SEWAGE DISPOSAL SYSTEM
HOWARD COUNTY HEALTH DEPARTMENT
BUREAU OF ENVIRONMENTAL HEALTH
410-313-2640

ISSUE DATE 7/9/2001

SUBDIVISION Big Branch Overlook LOT NUMBER 3 ADDRESS 14013 Big Branch Drive

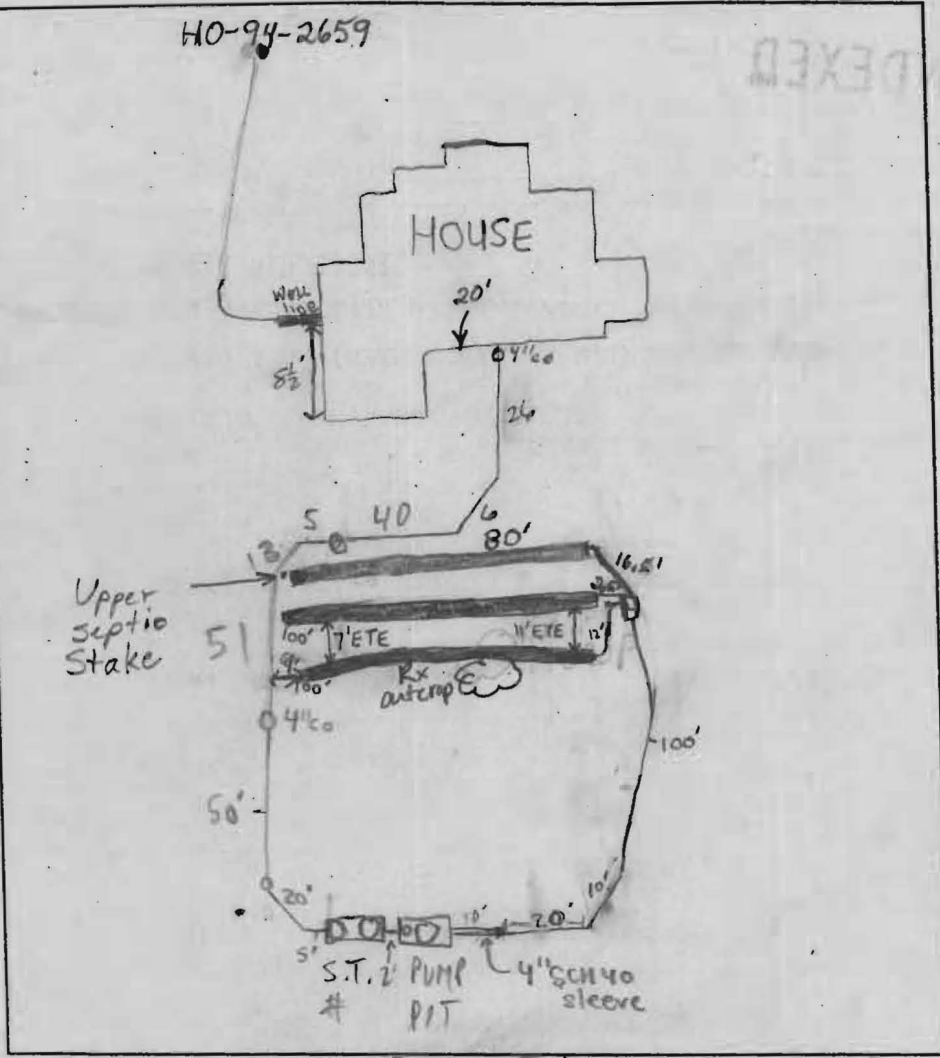
PRE-CONSTRUCTION INSPECTION: 7/27/01 Pre Const. layout - OK to proceed ALL

INSPECTION COMMENTS: 7/30/01 No significant work done. BB 7/31/01 S.T. #1 SET, Rx @ SITE #2 LG. Rx OUTCROP IN MIDDLE OF SRA CONTINUE MR

8/1/01 - SECOND SEPTIC TANK SET, OK TO CONTINUE, CALL DURING TRENCH INSTALLATION TO "WORK" AROUND ROCK IF ENCOUNTERED (SRK) 8/2/01 Rx OUTCROP NOT A PROBLEM, OK TO START TRENCHES, 10' HIGHER THAN RIGHT REAR SEPTIC STAKE MR/KG

8/3/01 - OK TO COVER & CONTINUE WORK, TOP TRENCH REMAINS TO BE INSTALLED

(SRK/KG) 8/6/01 O.K. to cover everything. Need pump and alarm test. BB

8-17-01 SEWER PUMP TEST, OK (KG)

80', 100', 100' AS DISCUSSED W/INSTALLER 8/2 MR/RG
